PN 83042-1: Mandatory Condensate “Y” Upgrade

NY Thermal Inc. has determined that the condensate Y located within the boiler may prematurely deteriorate, in applications where condensate acidity levels are unexplainably twenty times higher than normal. As NY Thermal Inc. cannot predict the occurrence of the anomaly, all Y fittings must be replaced immediately.

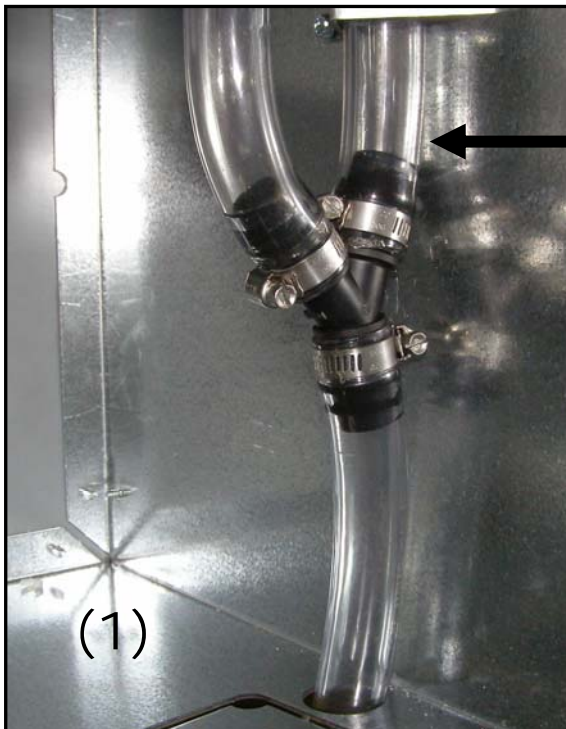
Trinity boiler Models Ti100, Ti150, Ti150C, Ti200 and Ti200C manufactured between Nov.28/05 and Jan.8/07 must be inspected. Boilers using the “Black-Y” in the construction of the condensate drain must be upgraded to the “Whitish-Y” included in this kit. (For Ti400’s use upgrade kit PN 83037-1.)

- 1) Identify the color of the Condensate Y; if it is black replace it.

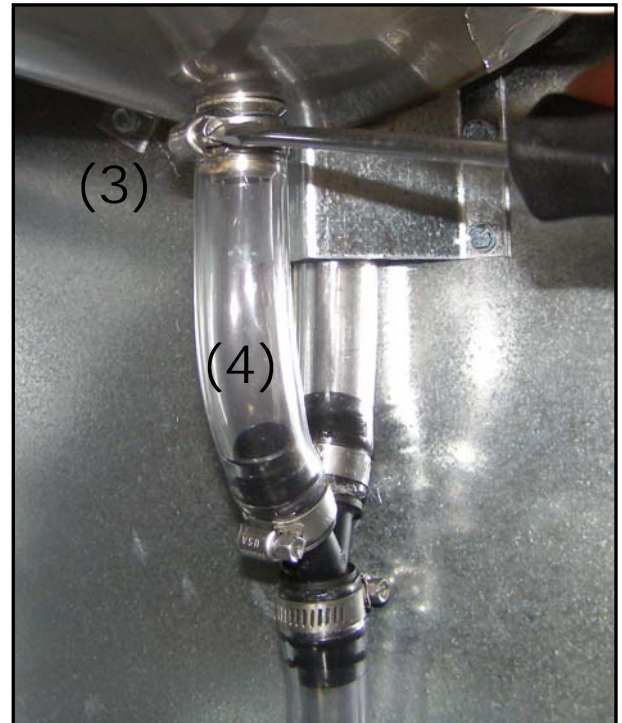
CAUTION: Do not cut or pull on this tube. It must remain connected to the boiler.

If the tube is disconnected from the back of the boiler, the boiler will need to be removed to repair.

- 2) Turn power off and remove the condensate trap from underneath the boiler.

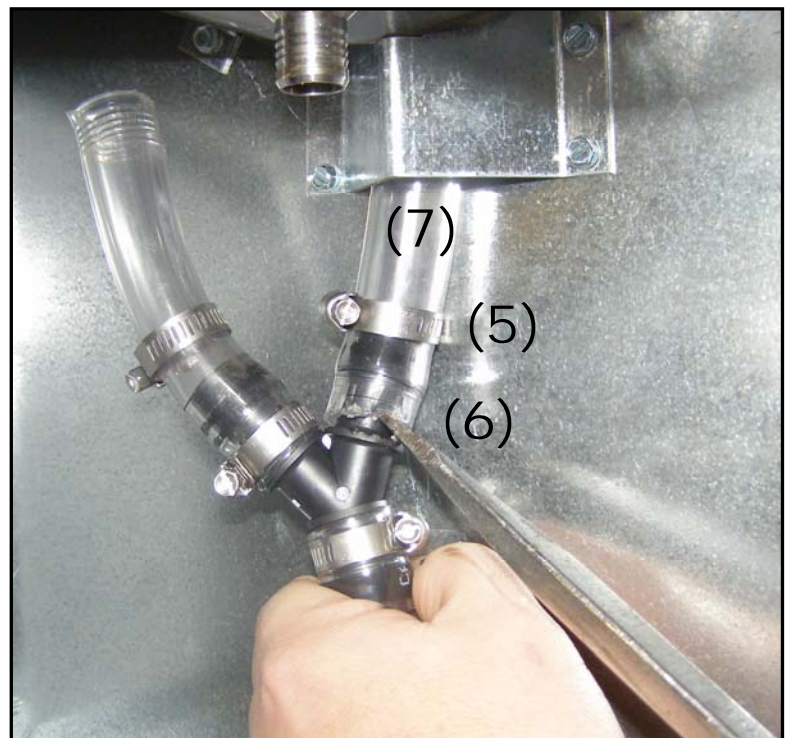
- 6) Very carefully, using a wide tipped flat screwdriver pry the tube off the "Y" connector.

- 7) **DO NOT PULL THE TUBING DOWN, AS IT MIGHT DISCONNECT FROM THE BACK.**

- 8) Remove the assembly and disconnect the remaining tubes from the old Y then re-install and secure the tubes onto the new Y (*Install longer tube on the bottom Y fitting*).
- 9) Install the new Y and connect the trap to the condensate drain.
